ANN ARBOR BUILDING BOARD OF APPEALS

STAFF REPORT

Building Board of Appeals Request **BBA22-2001** at 1299 Harpst St., ANN ARBOR, MI 48104

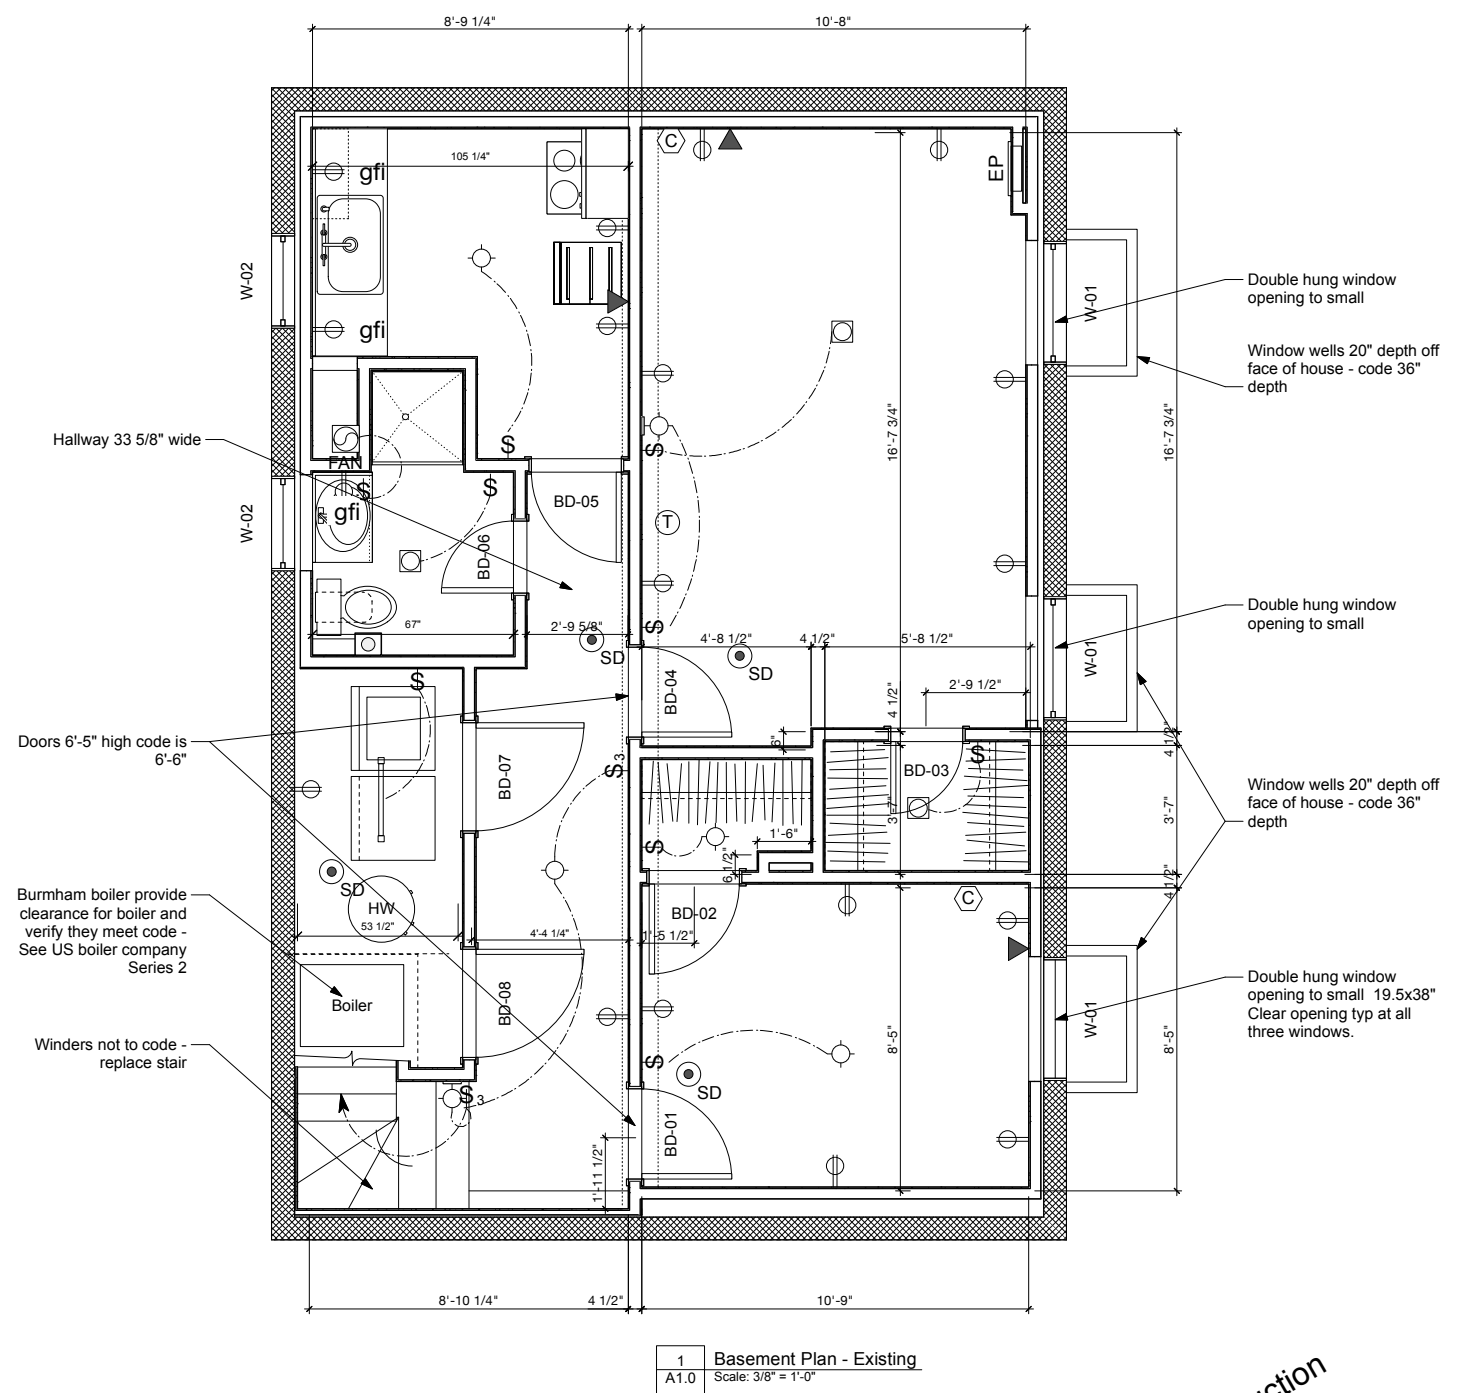
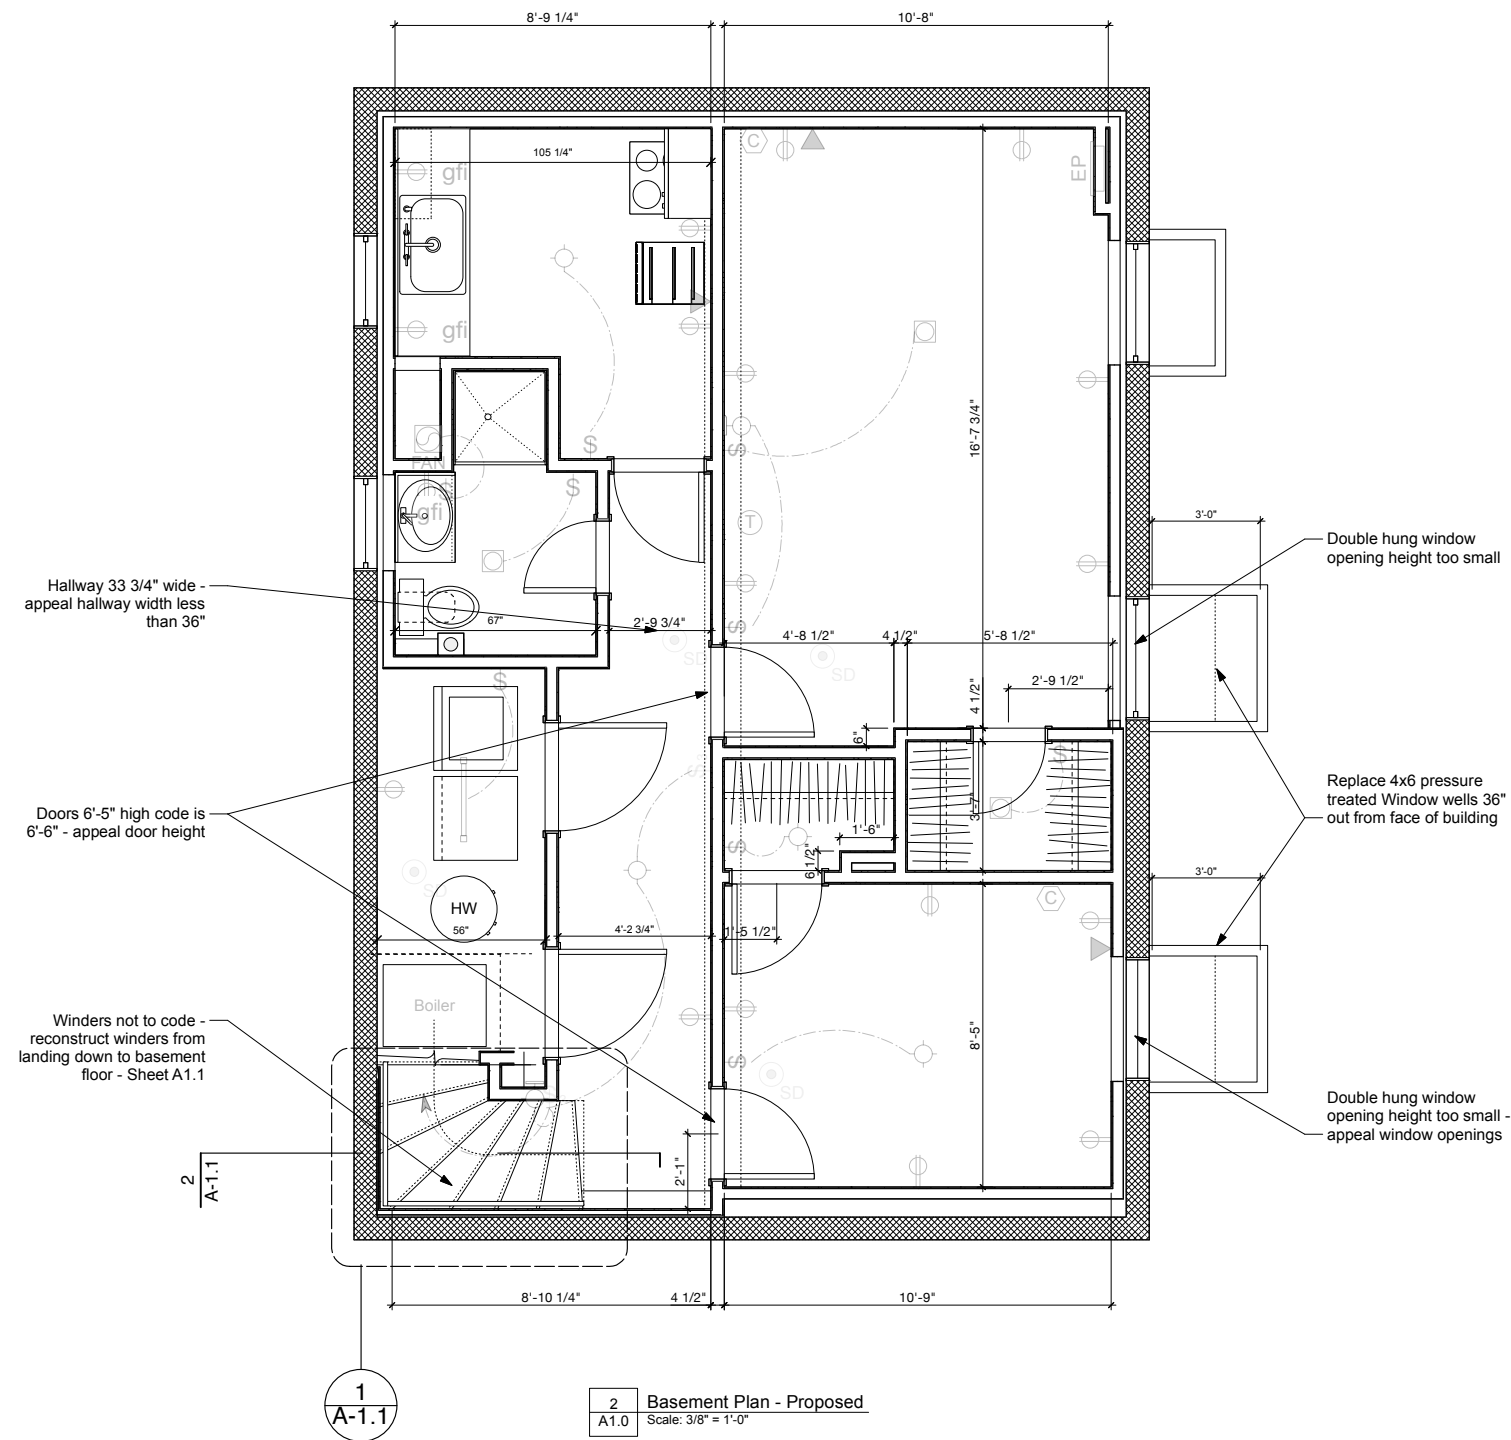
Two doors in the basement that connect the habitable rooms to hallway are 6'-4 1/2" in height to the carpet/ceramic tile floor. Section R311.2.1 states the doors shall be 6'-6" height. Note that flooring materials are 1/2" high. Which means the overall door opening from the basement slab is 6'-5" high. The current wall that the doors are located in is below the first-floor beam for the house and there is very little room between the door head and structural beam. We are requesting a variance for 1 inch discrepancy listed in the code for the height of doors.
